NEW ELEMENTARY SCHOOL  
9801 HIGHLAND KNOLLS DR  
BAKERSFIELD  
CALIFORNIA  
93306

NEW MIDDLE SCHOOL  
4115 VINELAND ROAD  
BAKERSFIELD  
CALIFORNIA  
93306

JOB NUMBER:  
20101244  
CAD DRAWING FILE:  
DRAWN BY:  
AC  
CHECKED BY:  
PH  
CHECK AND VERIFY ALL DIMENSIONS BEFORE  
PROCEEDING WITH THE WORK.  
REPORT DISCREPANCIES TO THE ARCHITECT.  
THE DRAWINGS, IDEAS, AND DESIGNS  
REPRESENTED ON THIS SHEET ARE THE  
PROPERTY OF THE ARCHITECT.  
COPYRIGHT  
ORDIZ-MELBY ARCHITECTS, INC. 2010  
SHEET TITLE  
**LIGHTING PLAN**  
**BUILDING N**

**Rfi 163**

SHEET IDENTIFICATION NUMBER  
**E-132N**  
SHEET OF

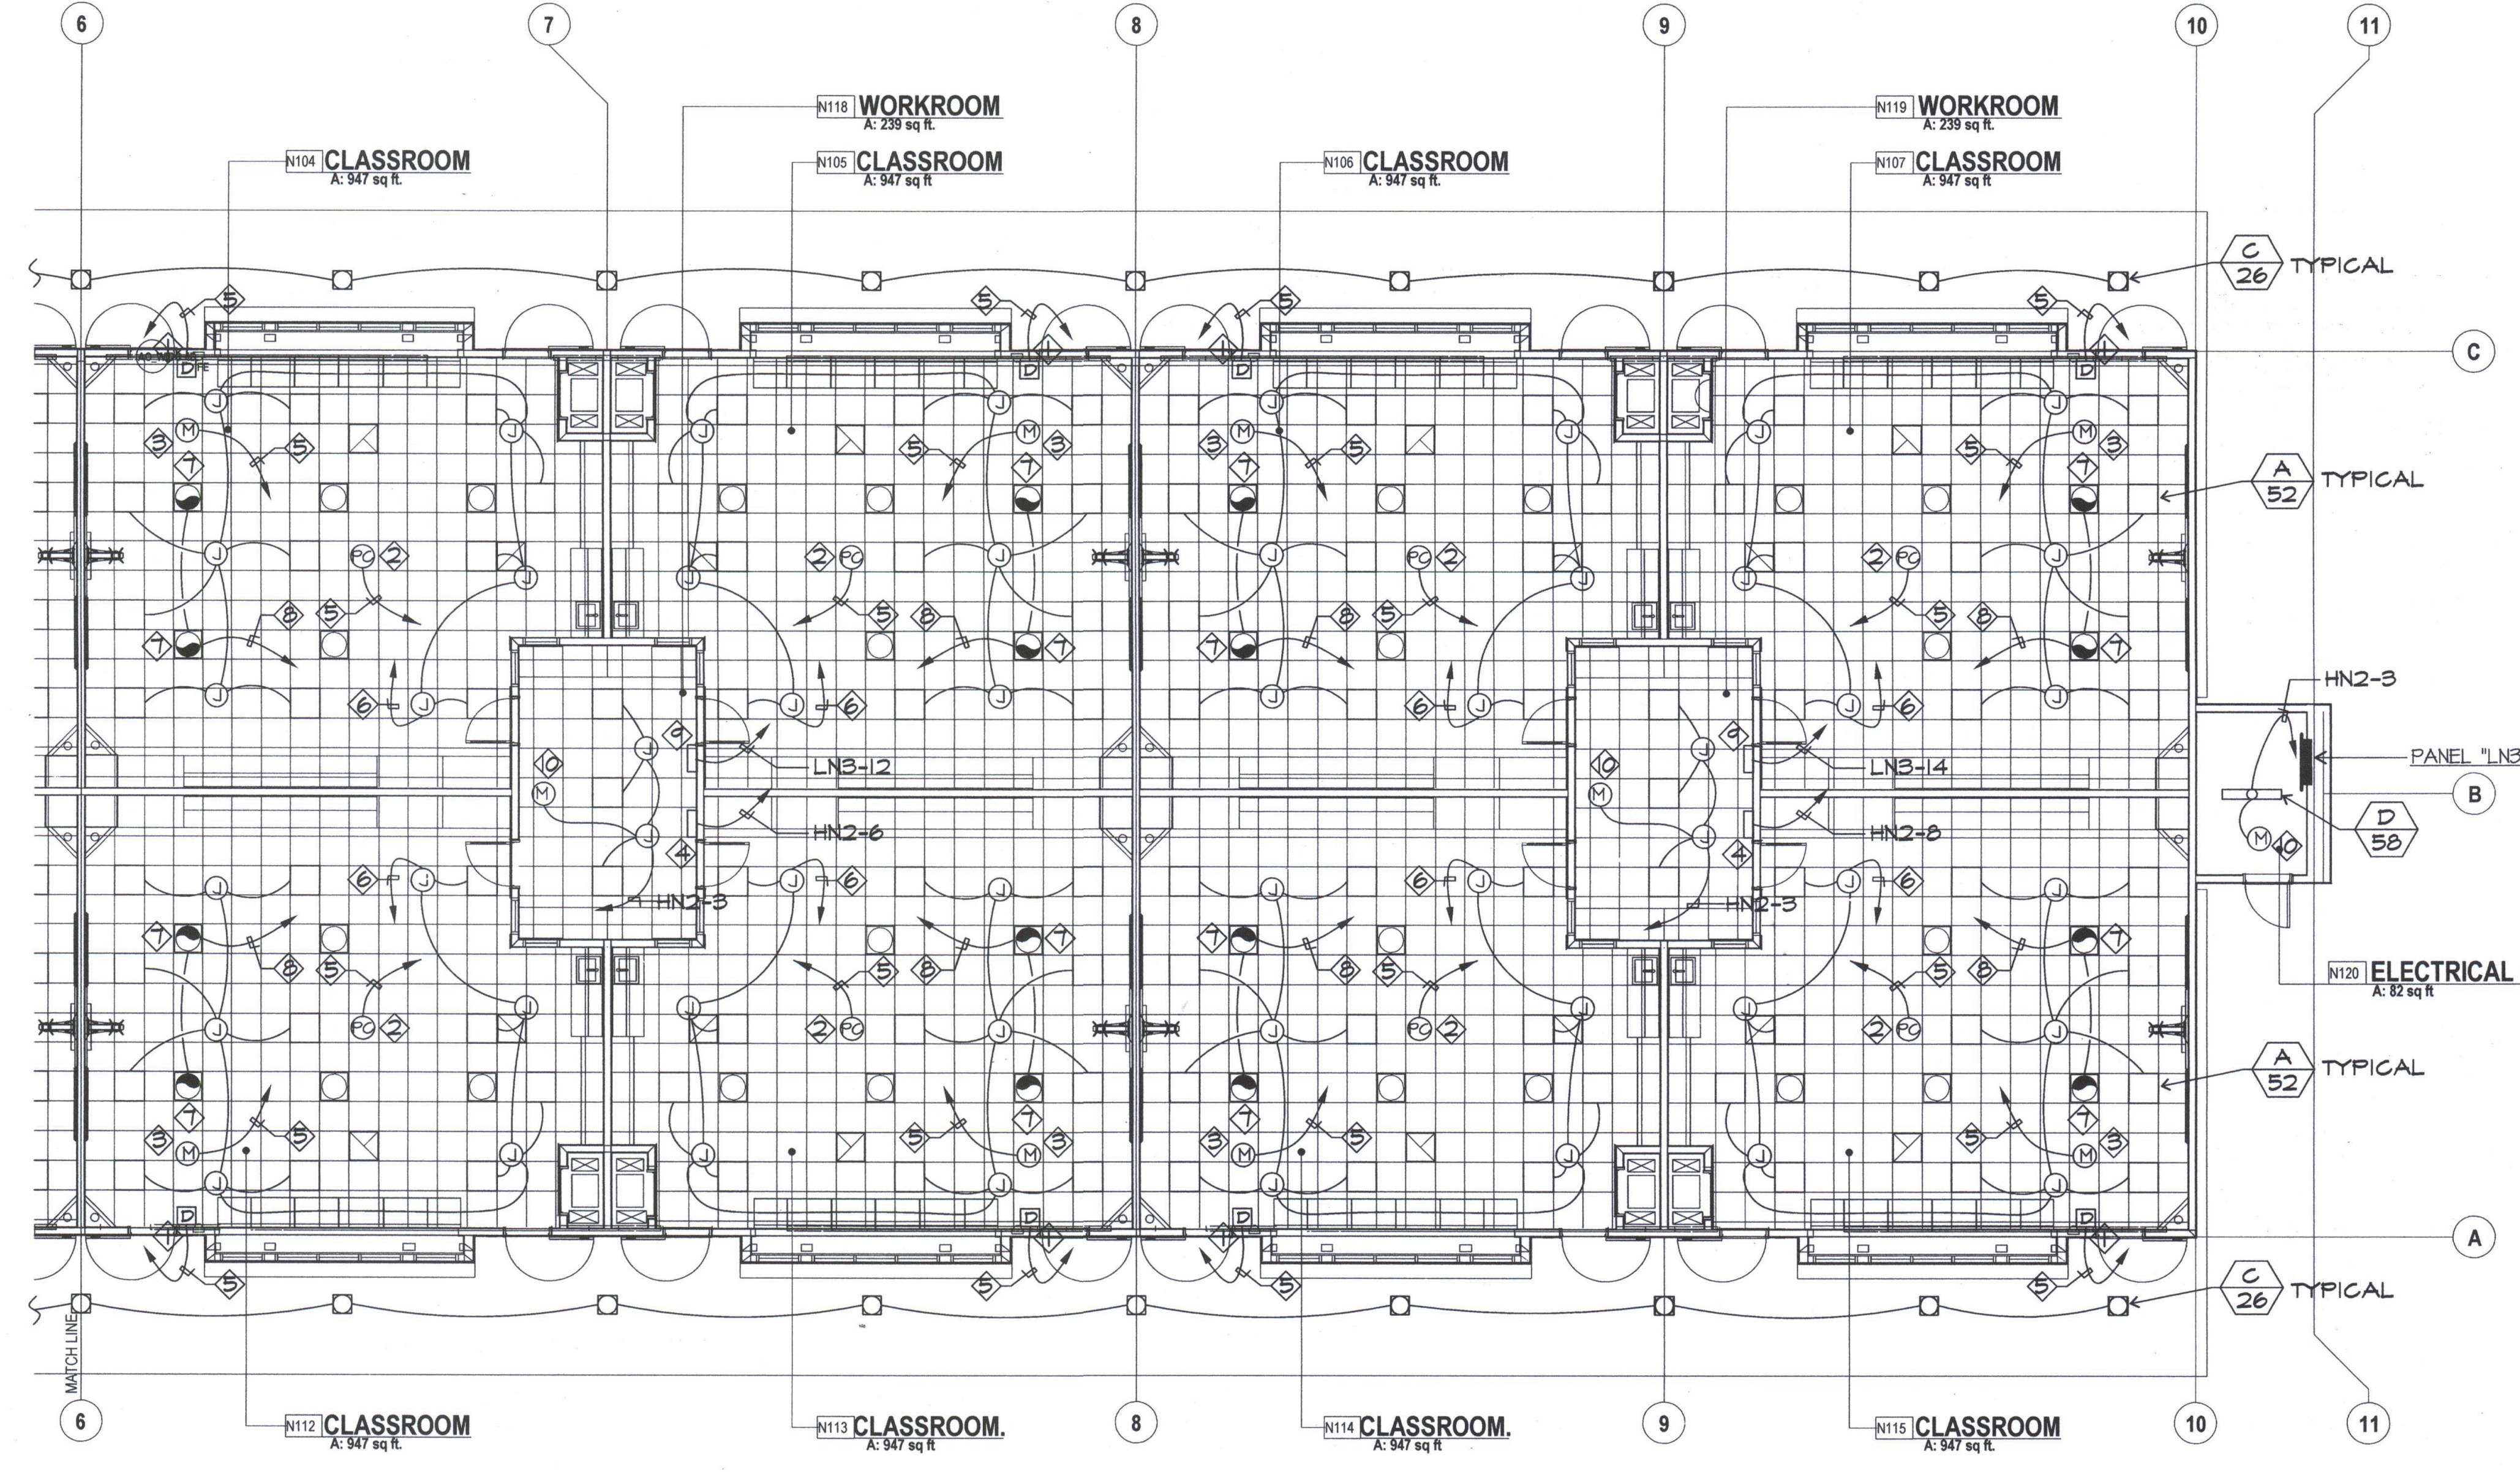
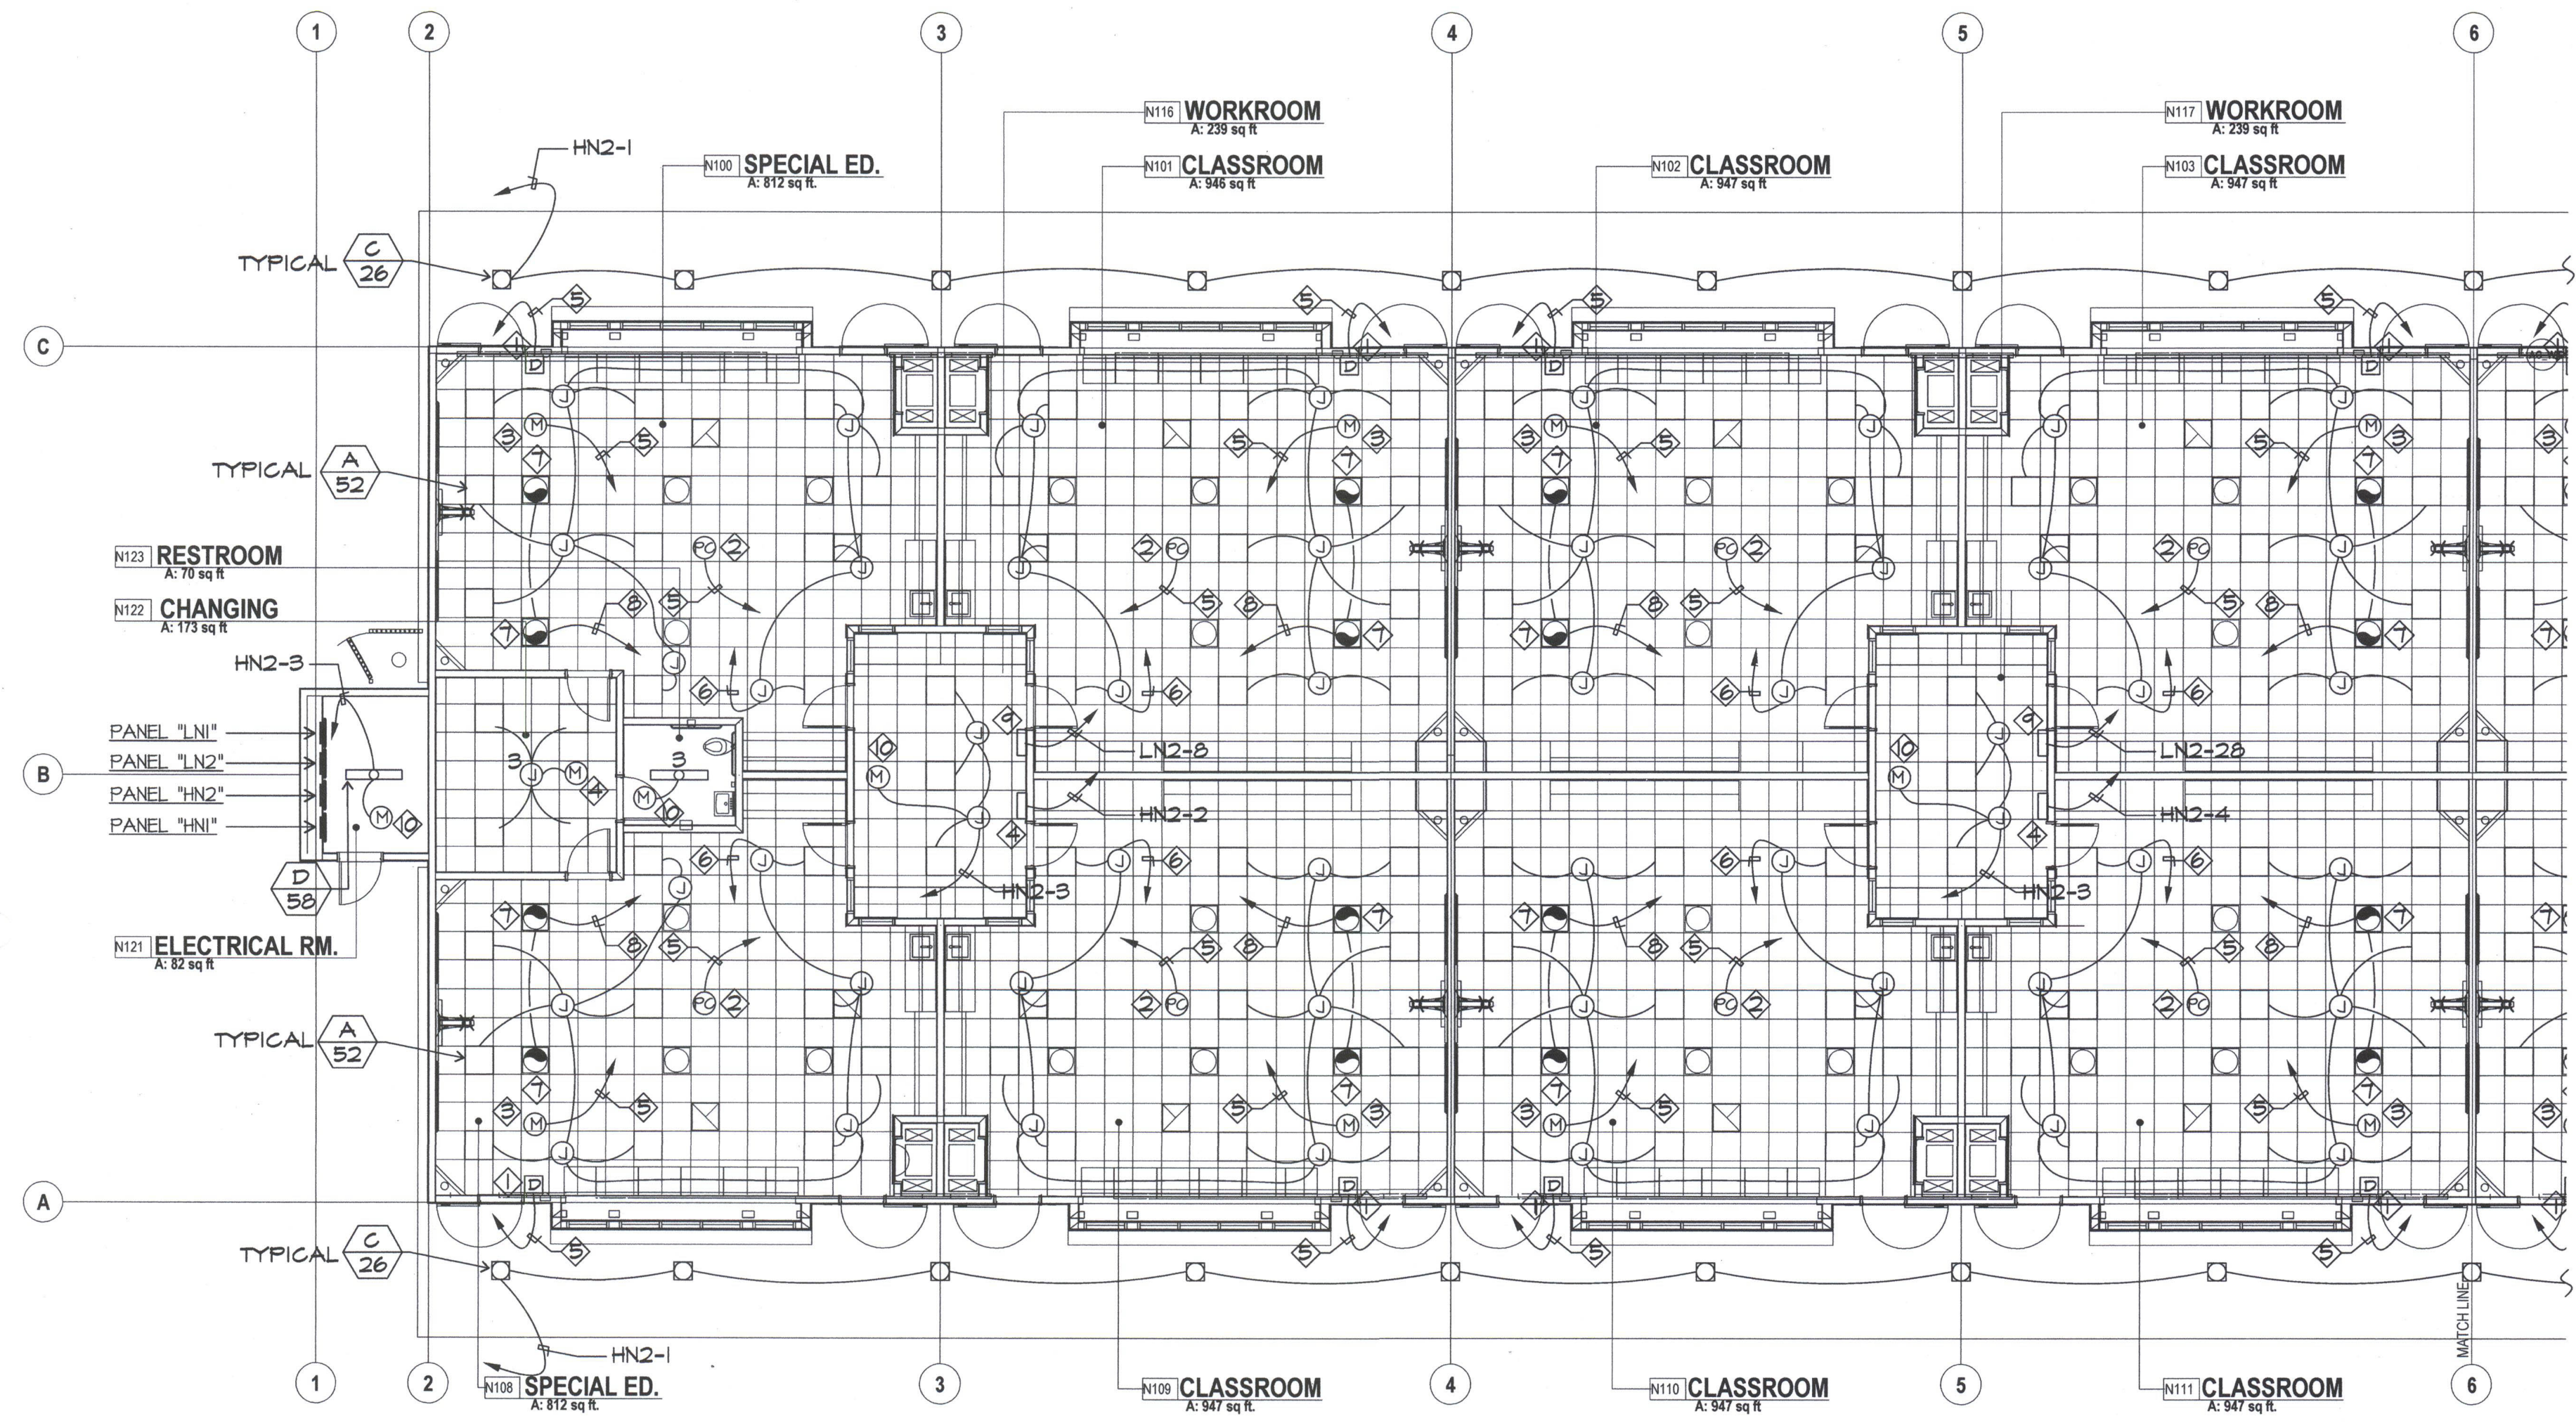
Request:  
RDM Electric - 10/9/12  
Reference Sheets E-000, E-132C, E-132D, E-132E, E-132F, E-132G, E-132H, E-132P & Lighting Submittal  
The General Notes on the Electrical Plans show the lighting dimmers to be installed for the lighting at +48" to top of box and the light switches to be installed at +42". A 5 button Lutron wall station is shown to be installed for the lighting controls in the classrooms. Please provide mounting height (elevation) for the classroom lighting control wall stations.

Answer:  
Joseph W. Covington - Ordiz-Melby (10/11/12)  
Install all switches and dimmers at +42" to the center of the box.

RDM Electric - 9/18/13  
Reference RFI #822 & Sheets E-132C, E-132D, E-132E, E-132F, E-132G, E-132H, E-132P & E-132P  
For the references in RFI #822, the solutions in the classrooms are to be controlled via an Energi Savr Node. However, per the attached cut sheets, the solutions appear to need separate DC switching to be controlled, which is not shown on the drawings. The plans only show to supply 120V to the solution via the Energi Savr Nodes. Do the classrooms need DC switching to be added as a means of controlling the solution? If so, please advise on the requirements.

John Mackony - JMPE - 9/19/13  
Contact closure on Energi Savr Node will operate shutter. We verified this with Skatube and Lutron.
